PROJECT  
LIVERPOOL HEALTH & ACADEMIC PRECINCT  
ELIZABETH STREET LIVERPOOL, NSW  
CLIENT  
HEALTH INFRASTRUCTURE  
14/77 PACIFIC HWY, NORTH SYDNEY NSW 2060

STATUS  
SSDA AMENDMENT

Approved Section: 4.55(1A)    Application: 55D-10388-Mod-1

DRAWING NO.  
A-SSDA-MSCP-07

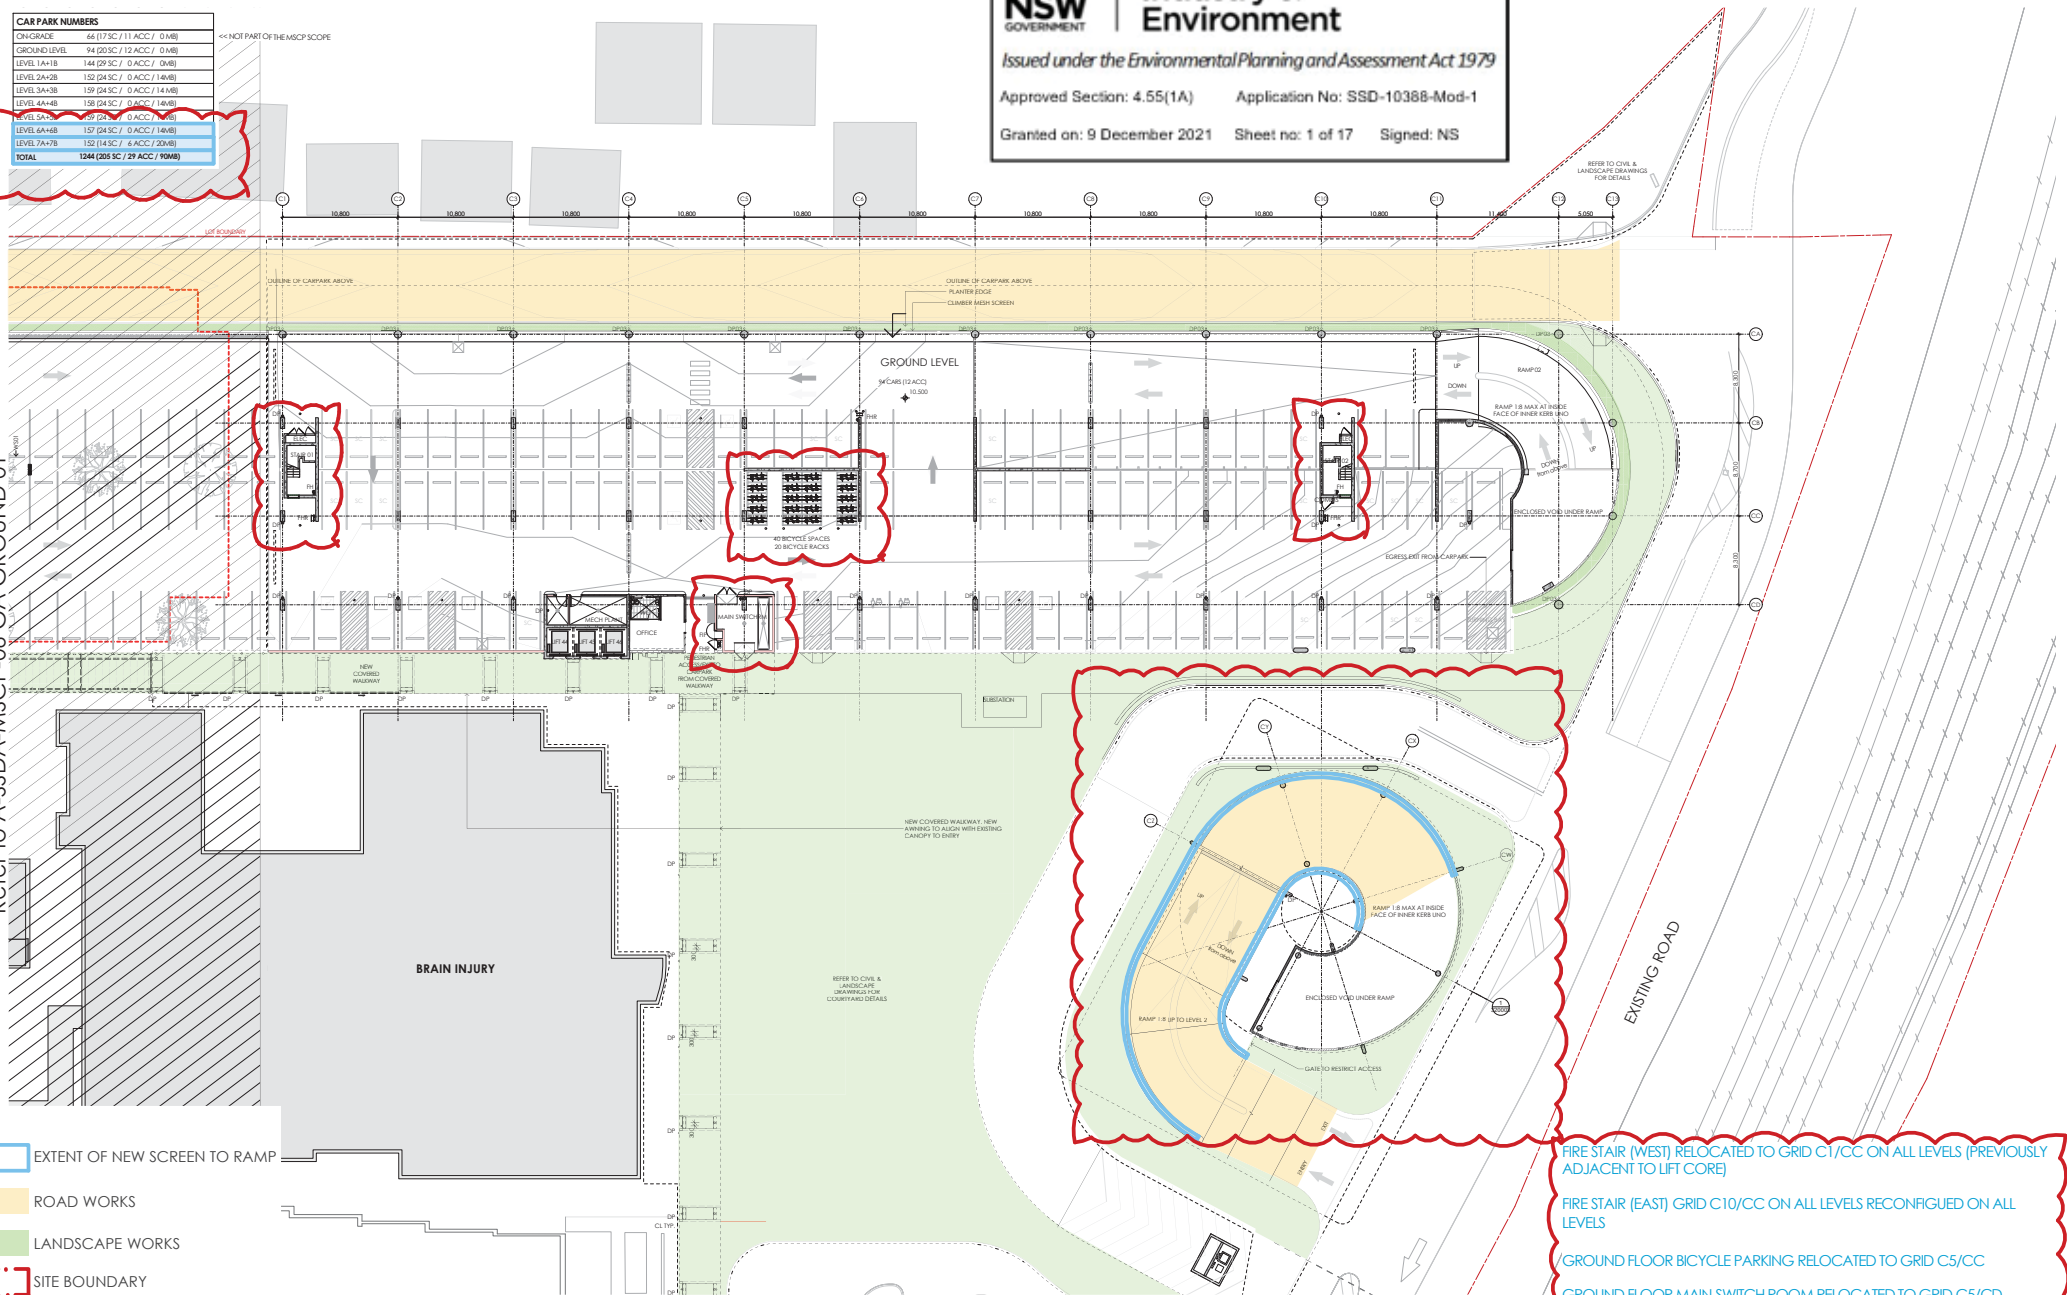
- FIRE STAIR (WEST) RELOCATED TO GRID C1/CC ON ALL LEVELS (PREVIOUSLY ADJACENT TO LIFT CORE)
- FIRE STAIR (EAST) GRID C10/CC ON ALL LEVELS RECONFIGURED ON ALL LEVELS
- GROUND FLOOR BICYCLE PARKING RELOCATED TO GRID C5/CC
- GROUND FLOOR MAIN SWITCH ROOM RELOCATED TO GRID C5/CD
- NEW SCREEN TO RAMP

PROJECT NO. 21807 DRAWING NO. A-SSDA-MSCP-08 ISSUE 08  
 STATUS: SSDA AMENDMENT

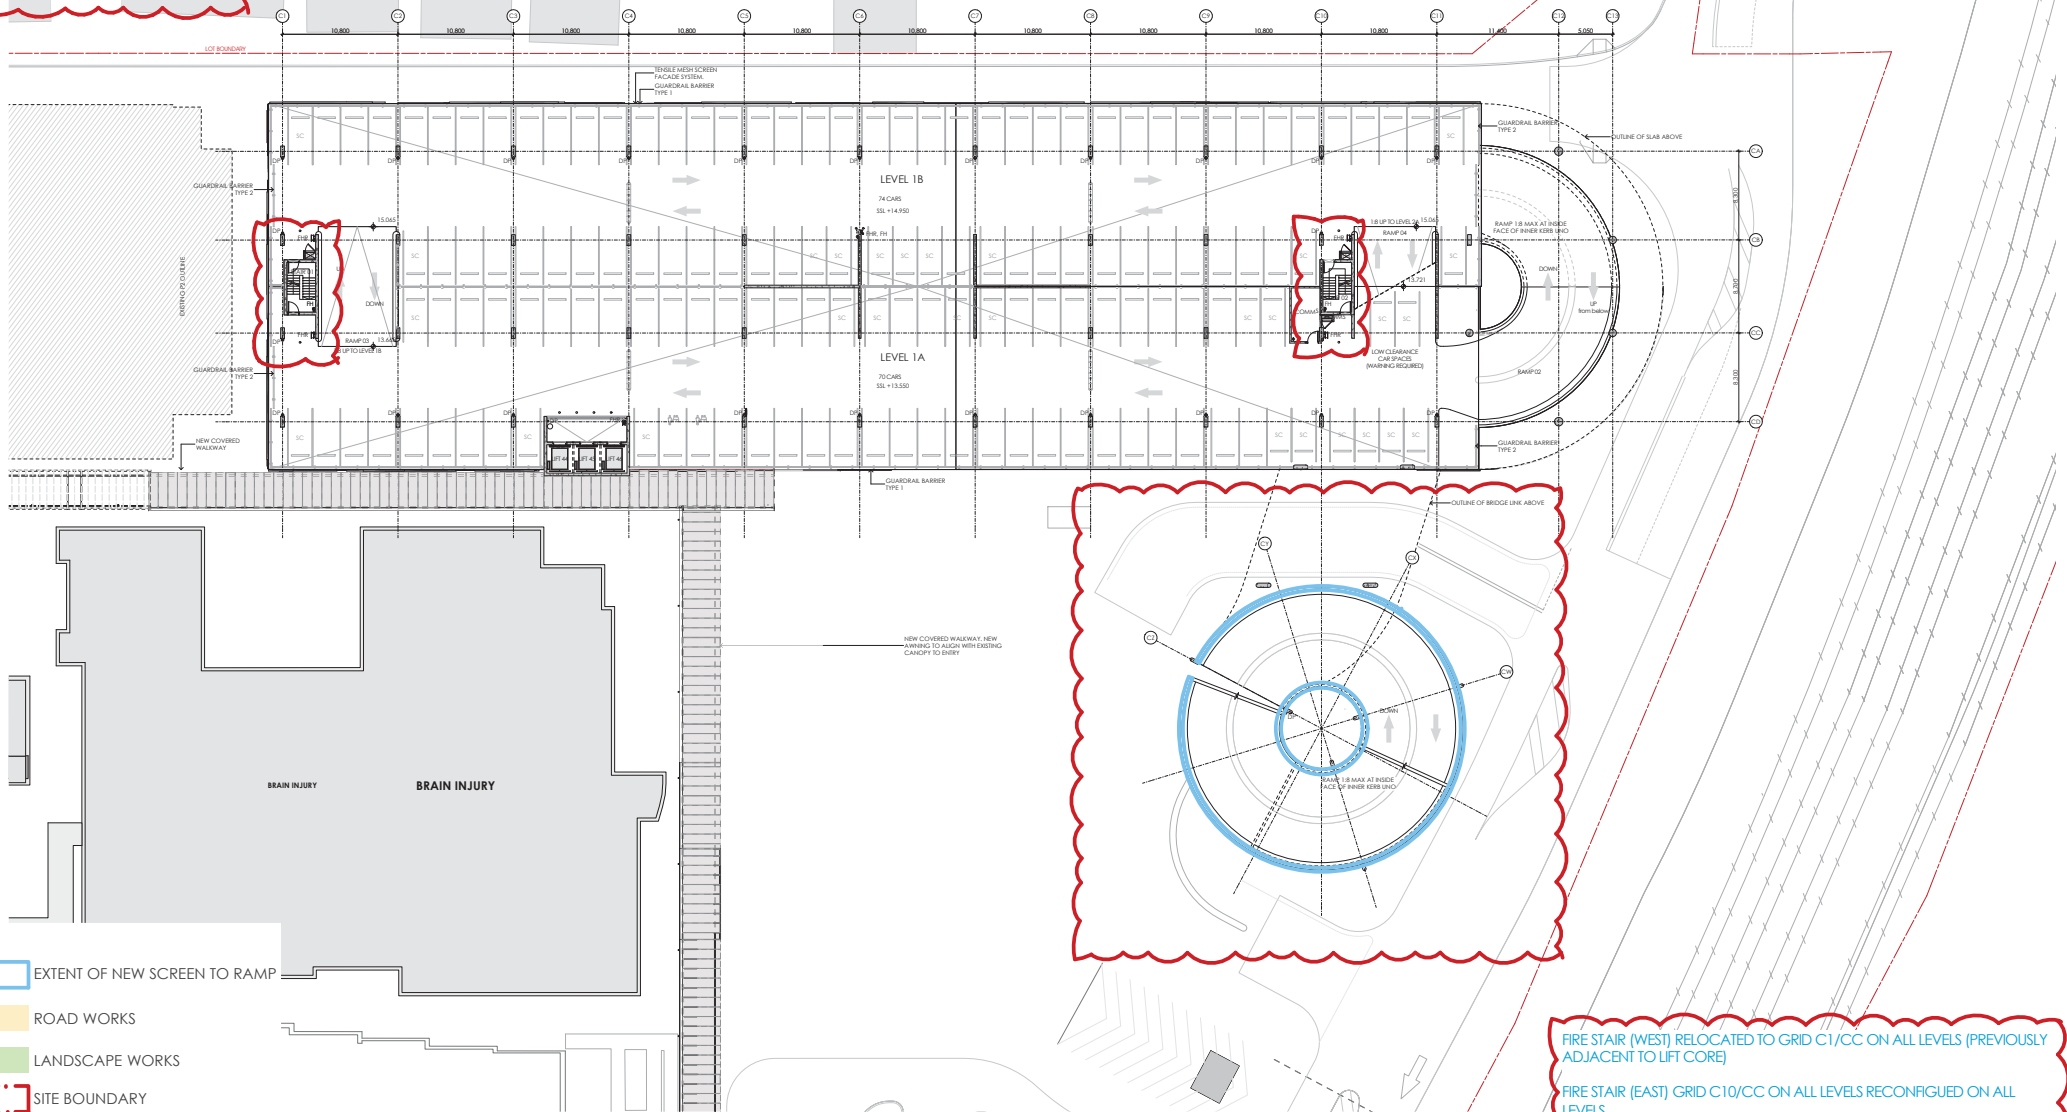
FIRE STAIR (WEST) RELOCATED TO GRID C1/CC ON ALL LEVELS (PREVIOUSLY ADJACENT TO LIFT CORE)  
 FIRE STAIR (EAST) GRID C10/CC ON ALL LEVELS RECONFIGURED ON ALL LEVELS  
 NEW SCREEN TO RAMP

PROJECT NO.	DRAWING NO.	ISSUE
21807	A-SSDA-MSCP-09	08
STATUS	SSDA AMENDMENT

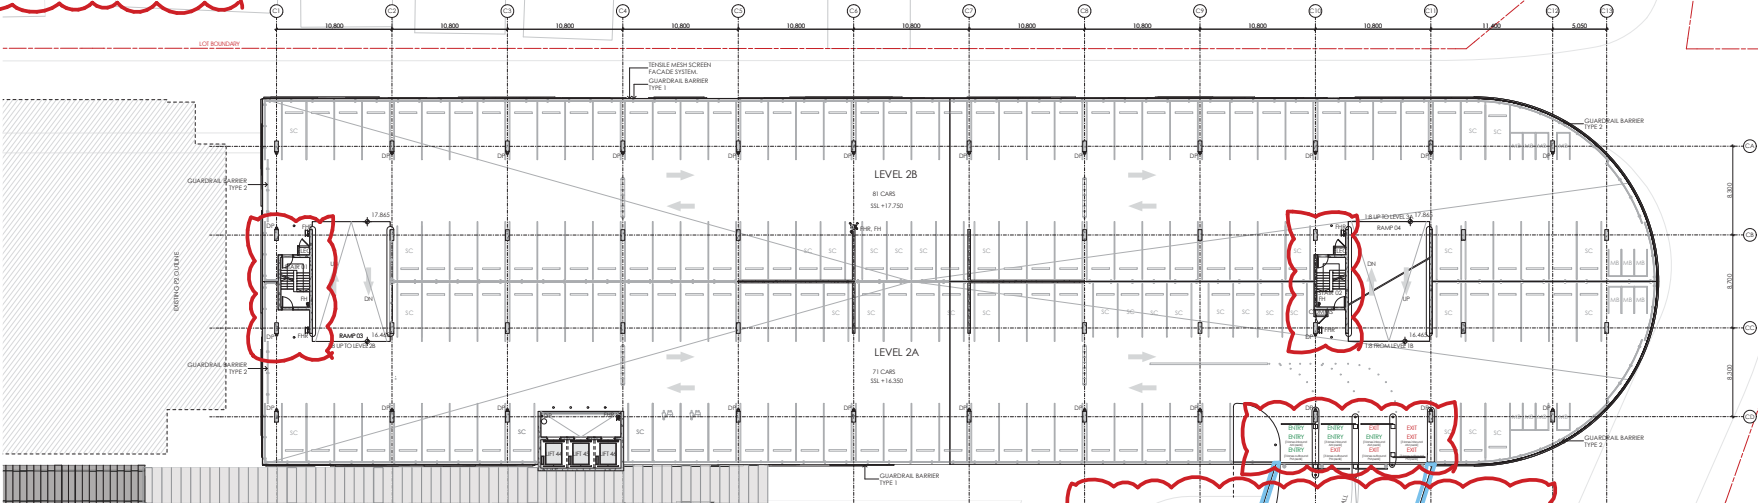
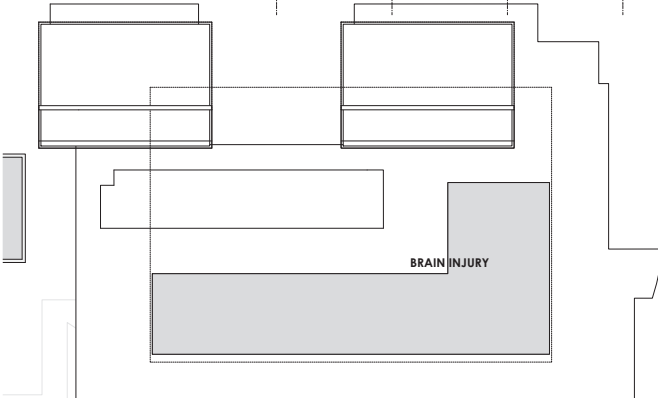
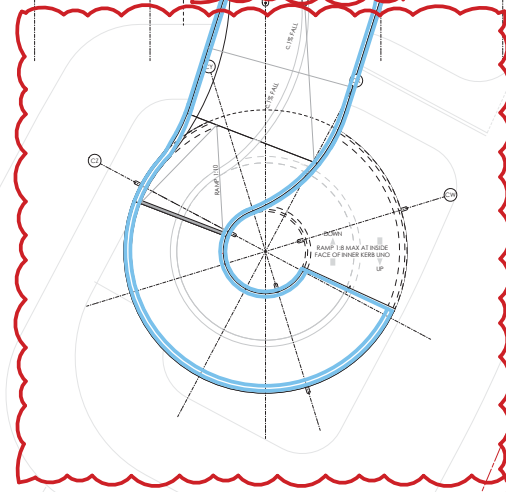
FIRE STAIR (WEST) RELOCATED TO GRID C1/CC ON ALL LEVELS (PREVIOUSLY ADJACENT TO LIFT CORE)  
 FIRE STAIR (EAST) GRID C10/CC ON ALL LEVELS RECONFIGURED ON ALL LEVELS  
 NEW SCREEN TO RAMP  
 + LEVEL 2 ENTRY DRIVEWAY RECONFIGURED TO ALLOW FOR TWO VEHICLE ENTRY LANES AND TWO VEHICLE EXIT LANES

PROJECT NO.	DRAWING NO.	ISSUE
21807	A-SSDA-MSCP-10	08
STATUS <b>SSDA AMENDMENT</b>

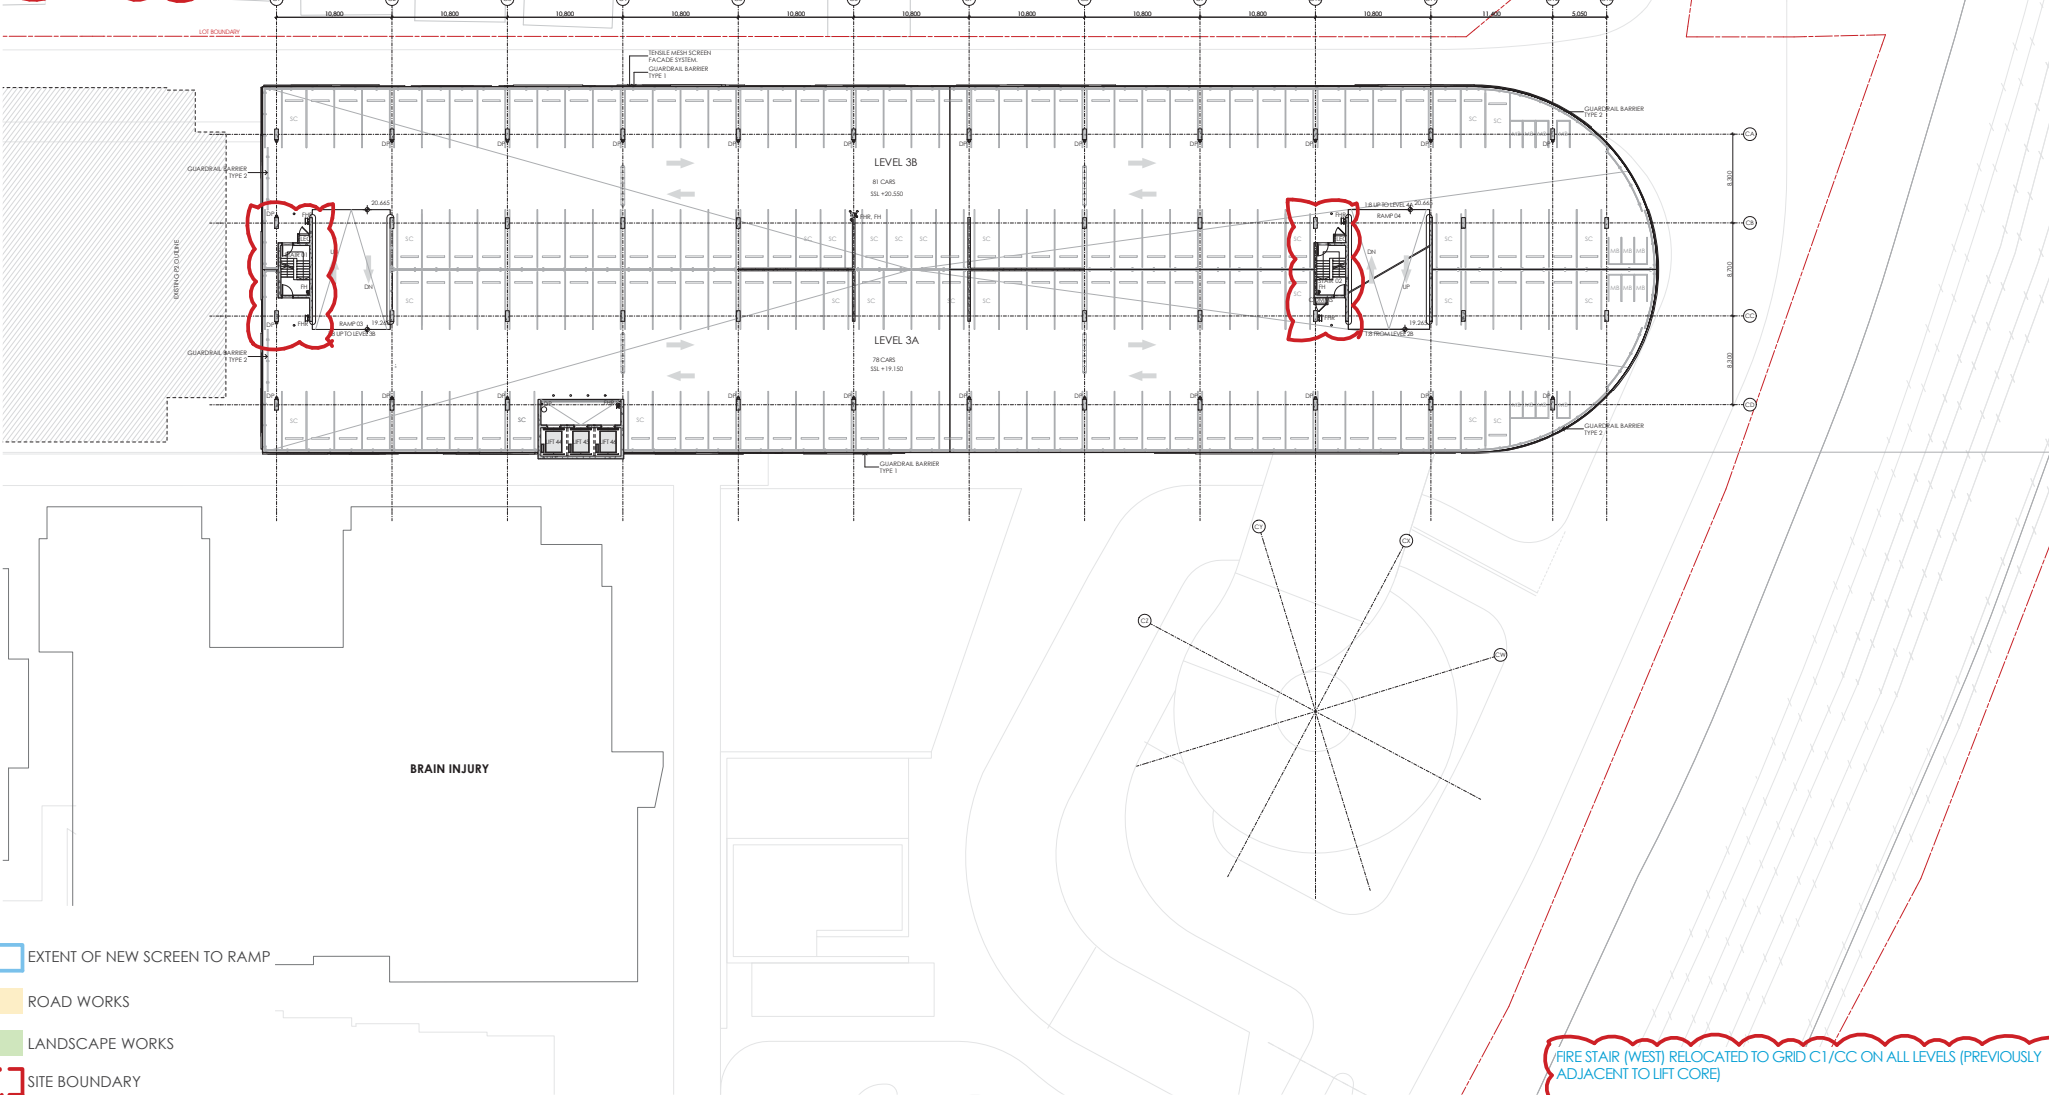
FIRE STAIR (WEST) RELOCATED TO GRID C1/CC ON ALL LEVELS (PREVIOUSLY ADJACENT TO LIFT CORE)

FIRE STAIR (EAST) GRID C10/CC ON ALL LEVELS RECONFIGURED ON ALL LEVELS

PROJECT NO.	DRAWING NO.	ISSUE
21807	A-SSDA-MSCP-11	08
STATUS		
<b>SSDA AMENDMENT</b>

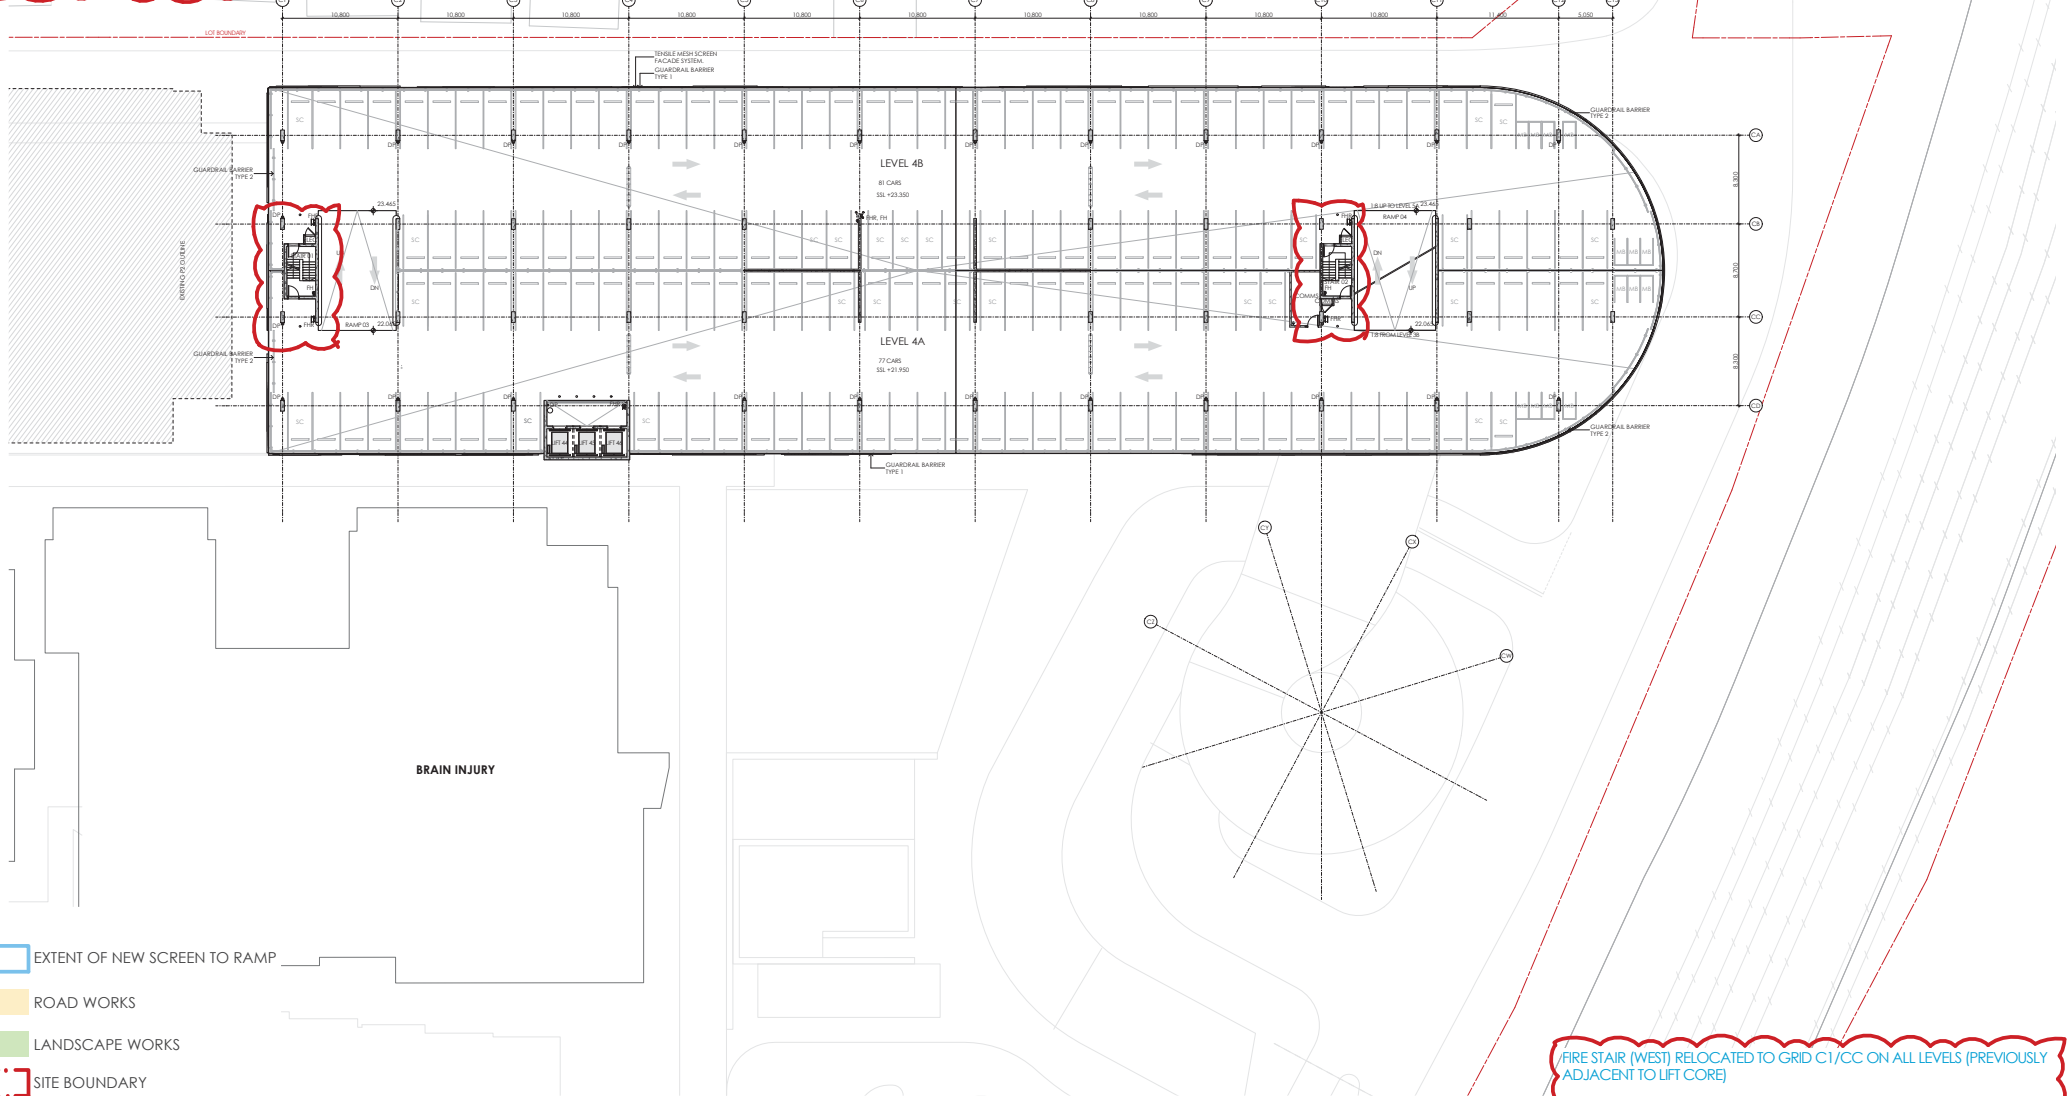
FIRE STAIR (WEST) RELOCATED TO GRID C1/CC ON ALL LEVELS (PREVIOUSLY ADJACENT TO LIFT CORE)  
 FIRE STAIR (EAST) GRID C10/CC ON ALL LEVELS RECONFIGURED ON ALL LEVELS
